Work Order ID 122944

Item ID: D4464-041 Accept *N900040100* Setup Start *NS1*
 Revision ID: Stop *NS2*
 Item Name: Fuel Tank Assembly
 Start Date: 7/29/14 Start Qty: 1.00 *1* Cust Item ID:
 Required Date: 7/29/14 Req'd Qty: 1.00 *1* Customer:
 Reference:

D4464-041 FUEL TANK ASSEMBLY
D4463-9 TANK BACK REMOVED
TO SHOW INTERIOR DETAIL

DETAIL A
ROTATED FOR CLARITY
SCALE 2X

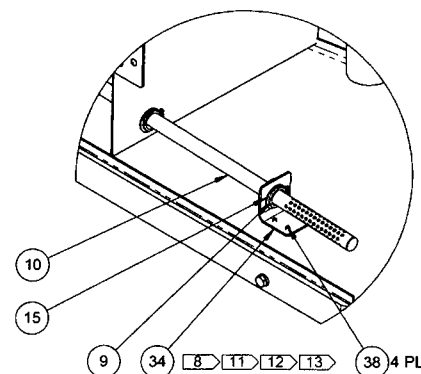
Remove grommet. Open
hole as req'd to
allow D4000-045
to pass. Ensure at
least 1/8" CLEARANCE.

Root Cause	Date	Step	Qty	Description of work order update or non-conformance	Initial Chief Eng	Action Description	Sign & Date	Verification	QC Inspector
Design	14/12/3	120	1	Hole in baffle interferes with D4000-045. DESIGN PROBLEM D4000-045 will not thread into D4000-1. Requires that D4000-1 be at 2.8" angle. DESIGN problem.	DAS 12 9-89 14/12/3	Remove plastic grommet and open interfering hole to clear D4000-045. Ensure at least 1/4" clearance around D4000-045. Touch up cladding and ensure no chips in tank. Install D4000-1 with 6061-T6 Shim (B/N 101674) to correct angle. Install w/ pre-set and longer rivets as req'd.	15/01/20 DAS 36 9-89	DAS 30 9-89 15/01/30	DAS 9 9-89 15-01-30
Doc/Data									
Equip/Tooling									
Handling/Pre									
Material									
Operator									
Offset/Setup									
Process									
Supplier									
Training									
Transport									
Unapproved

SHIM FOR D4000-1

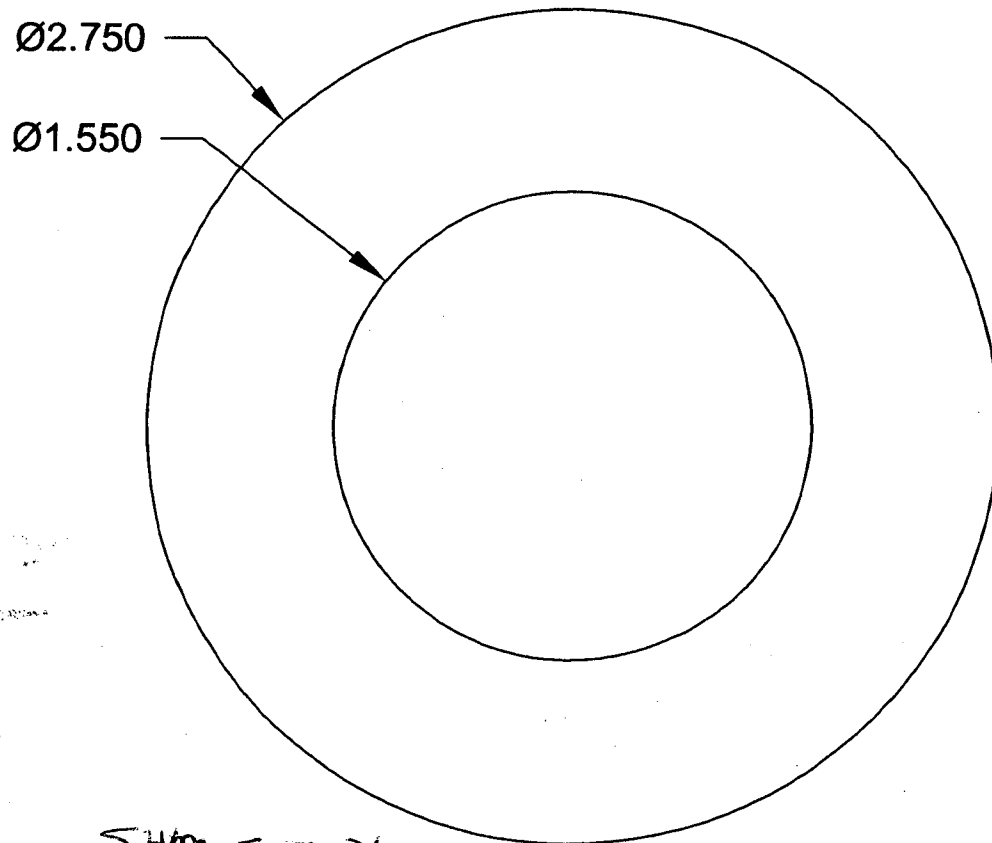
Root Cause	Date	Step	Qty	Description of work order update or non-conformance	Initial Chief Eng	Action Description	Sign & Date	Verification	QC Inspector
Design ☒			1	had to add shim need add.	A.P.	ACCEPTABLE TO SUBSTITUTE RIVETS LENGTHS 1.5X DIA PAST EDGE OF SHEET.	14/12/17	DAS 9 9-89	DAS 9 9-89
Doc/Data ☐					14.12.17				
Equip/Tooling ☐									
Handling/Pre ☐									
Material ☐	14/12/17	120		(5) MS 20470 AD 4-8 M 962			DAS 36 9-89	14-12-17	14-12-17
Operator ☐				(3) MS 20470 AD 4-7 M 123525					
Offset/Setup ☐				P.C. change in design. - shim was added in					
Process ☐									
Supplier ☐									
Training ☐									
Transport ☐									
Unapproved ☐
